**CHARTER TOWNSHIP OF VAN BUREN  
PLANNING COMMISSION AGENDA  
Wednesday, November 9<sup>th</sup>, 2022 – 5:30 PM  
Van Buren Township Hall  
46425 Tyler Road**

**ITEM # 1: CHRIS GARNER / SB – INVEST L.P. (BROOKWOOD) – PUBLIC HEARING**

**ITEM #1: COBBLESTONE CREEK PHASE VILLAS REVISION– SPECIAL LAND USE REVIEW**

TO: Van Buren Township Planning Commission  
FROM: Dan Power– Director of Planning and Economic Development  
RE: Case 21-044 – Cobblestone Creek Villas PRD Amendment  
DATE: November 3, 2022

**TYPICAL UNIT LAYOUT**

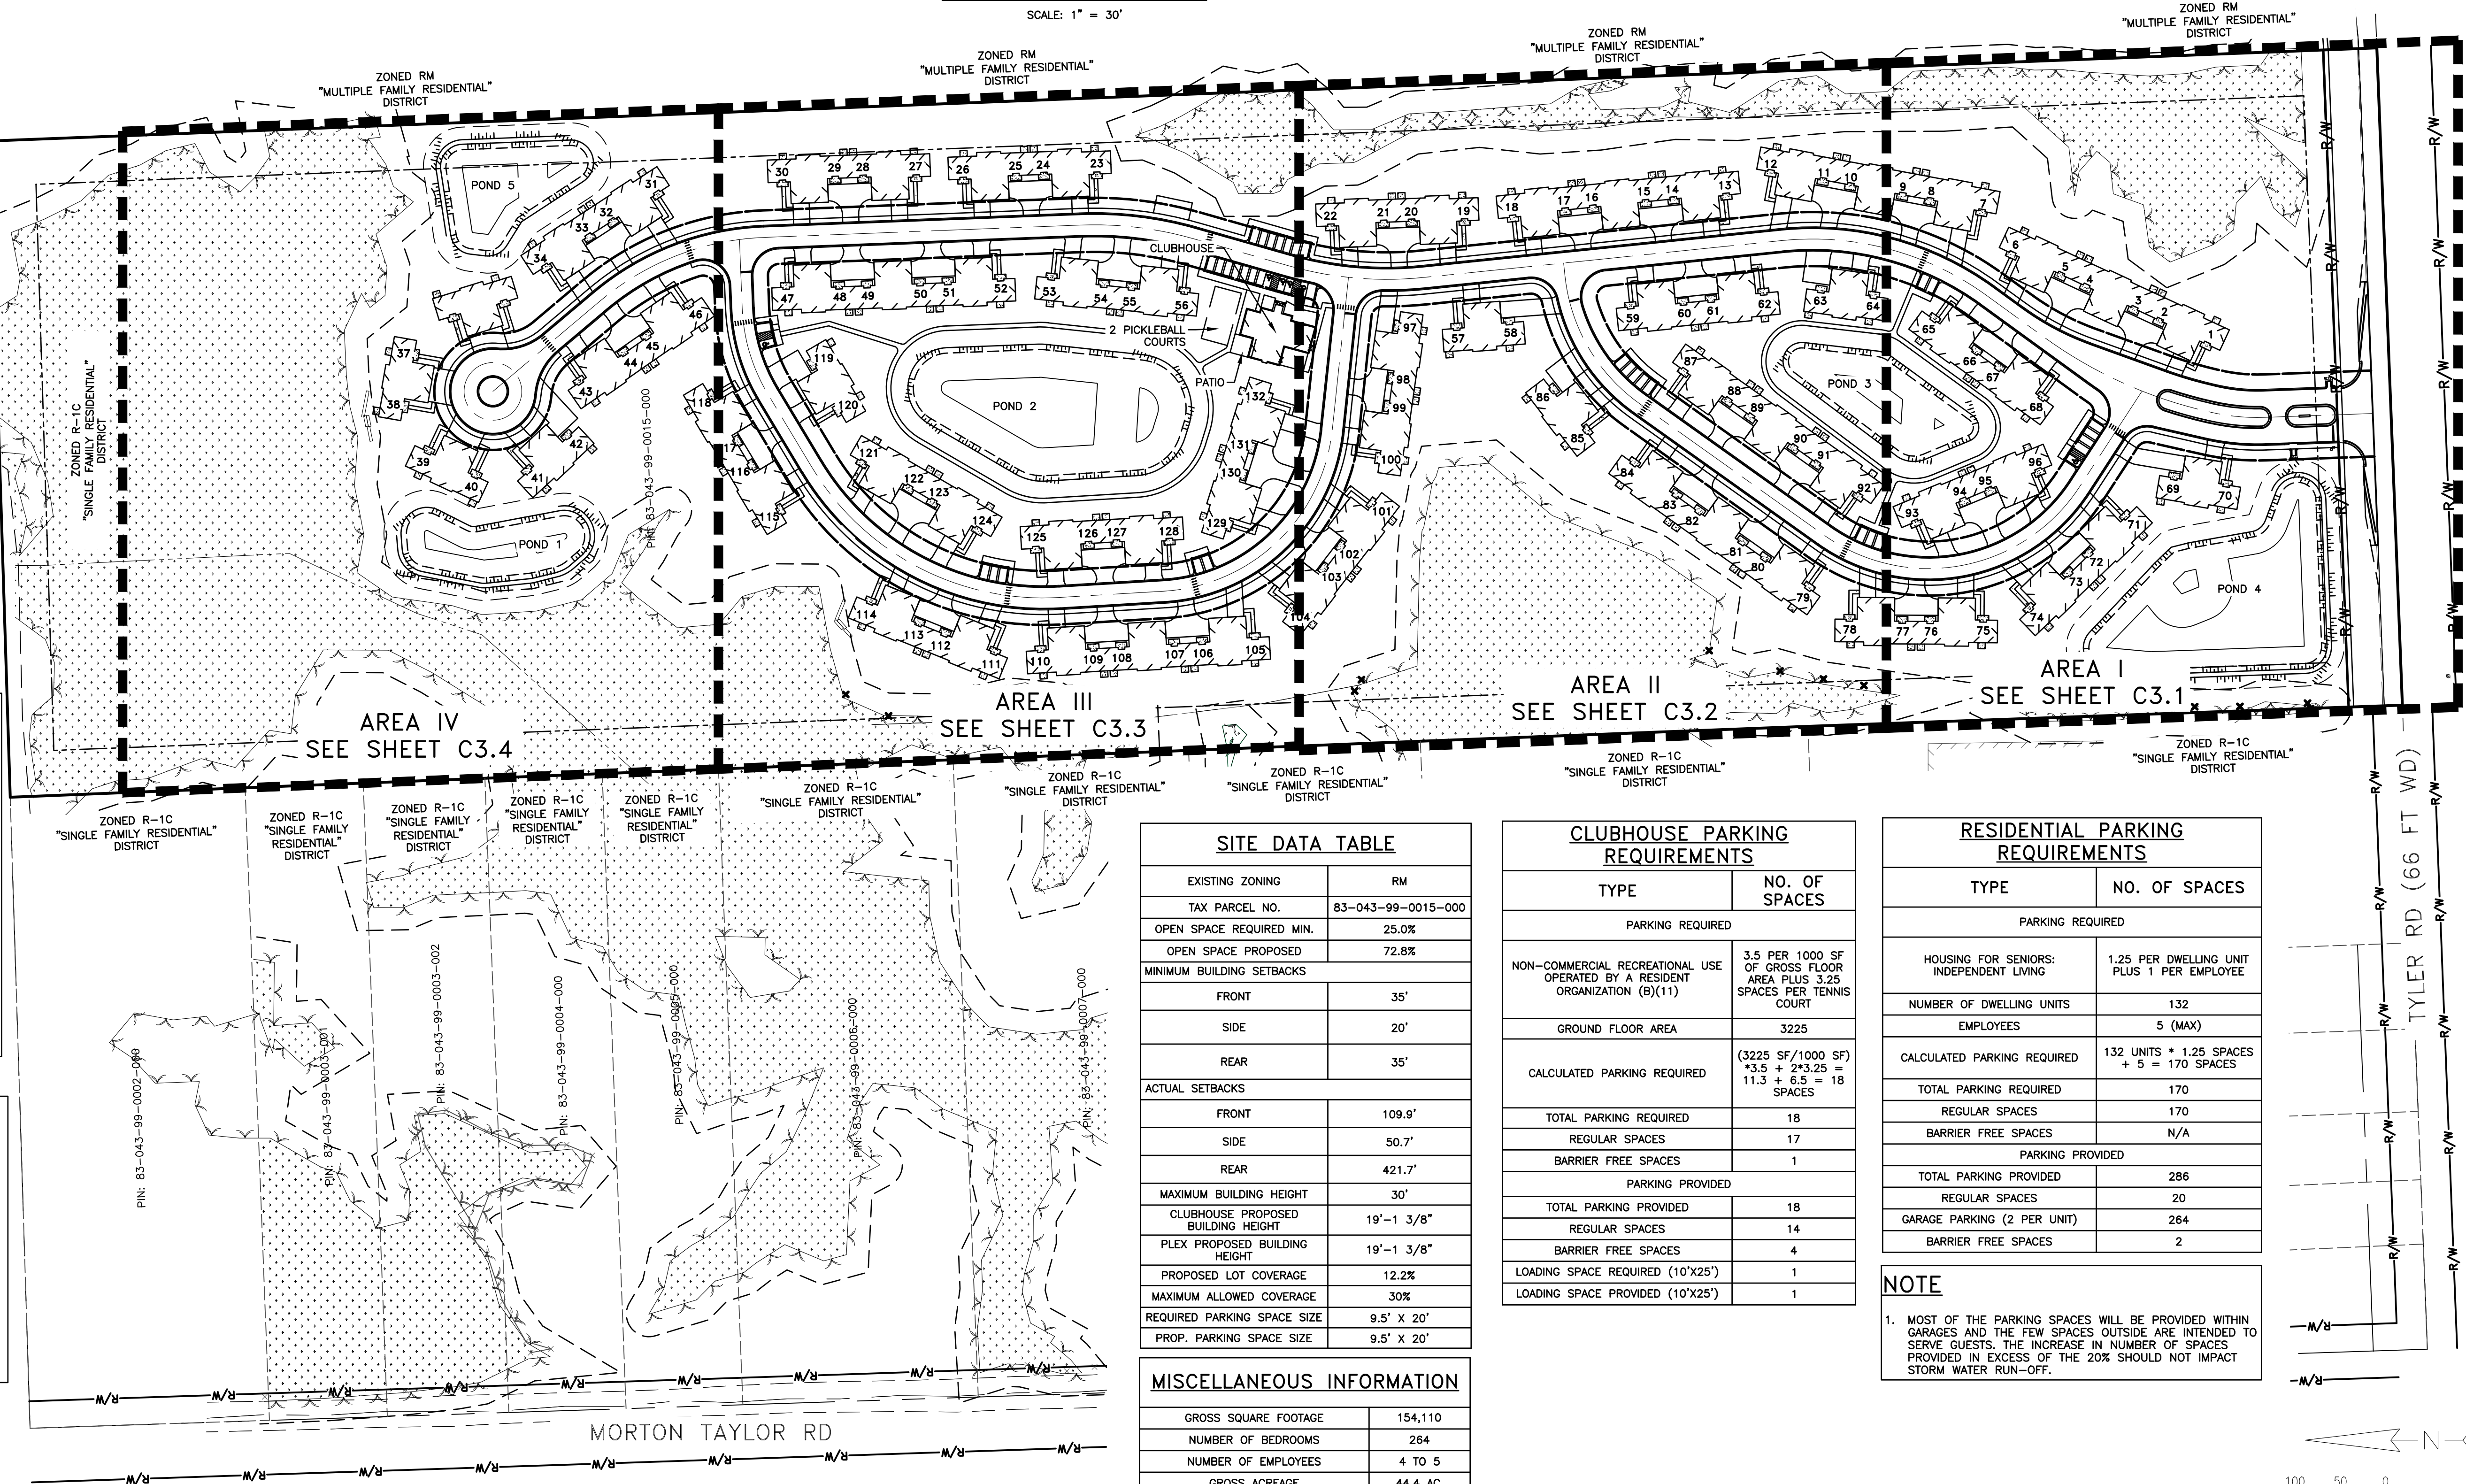
2. **The required minimum usable floor area for two-bedroom independent living units is 850 square feet.** This standard can be met. All units proposed are two-bedroom; however, the square footage of the typical unit must be clearly noted on Sheet C3.0 and must have a minimum area off 850 sq. ft.

Van Buren Township prohibits parking in excess of 20% of the minimum required. The site plan includes a note on Sheet C3.0 stating that most of the parking is within garages and that the additional parking area is intended to serve guests and should not impact stormwater run-off. The Planning Commission can grant relief from this standard per Section 9.101(I).

G1 SIGN  
AC200  
SCALE - 1/4" = 1'-0"

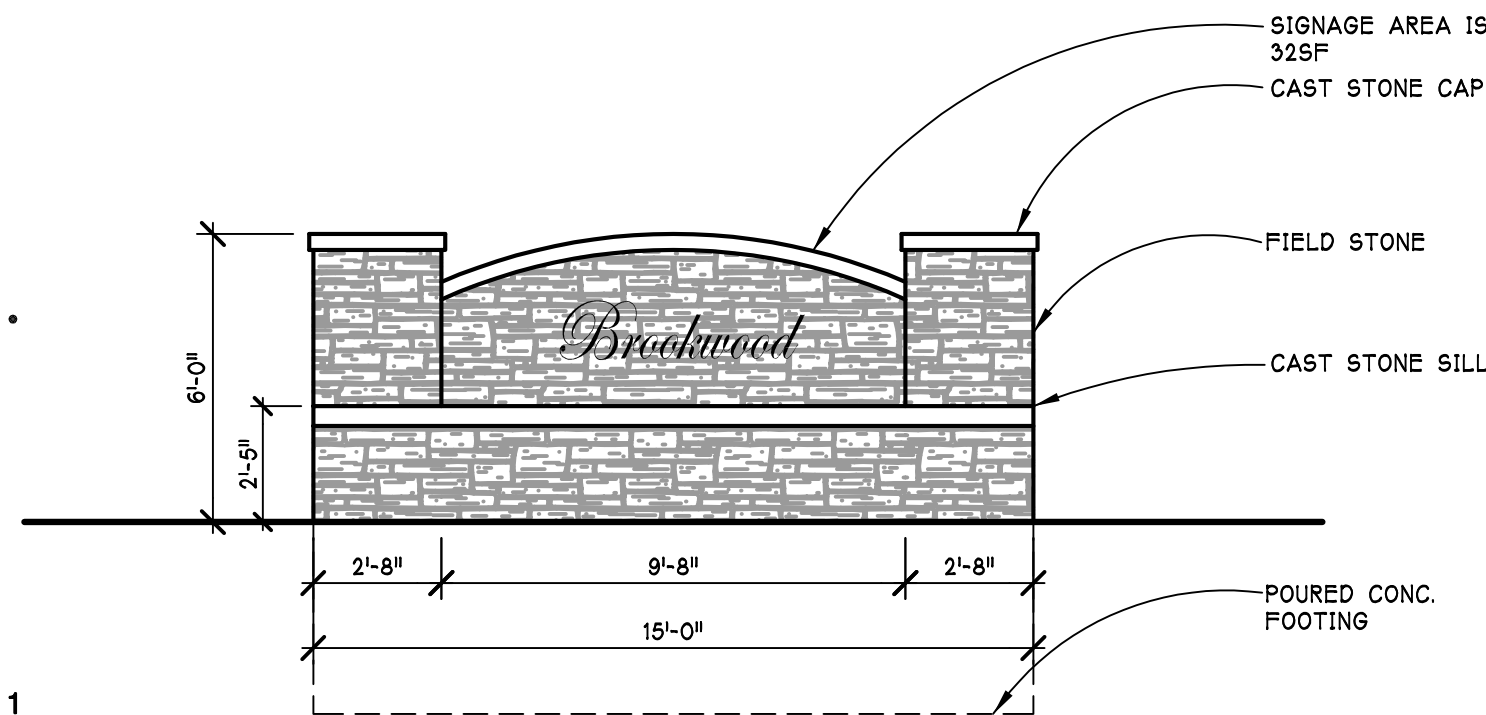
**13. Signs.** The site plan includes a monument sign at entrance drive to the site, off Tyler road. Details have been provided on Sheet AC200. The ordinance requires that the sign location must conform to the underlying zoning district. In case of the subject site, the RM zone requires a 30' setback for the sign. The revised plan notes the sign placed 30 feet from the front property line, as required per Section 11.108.
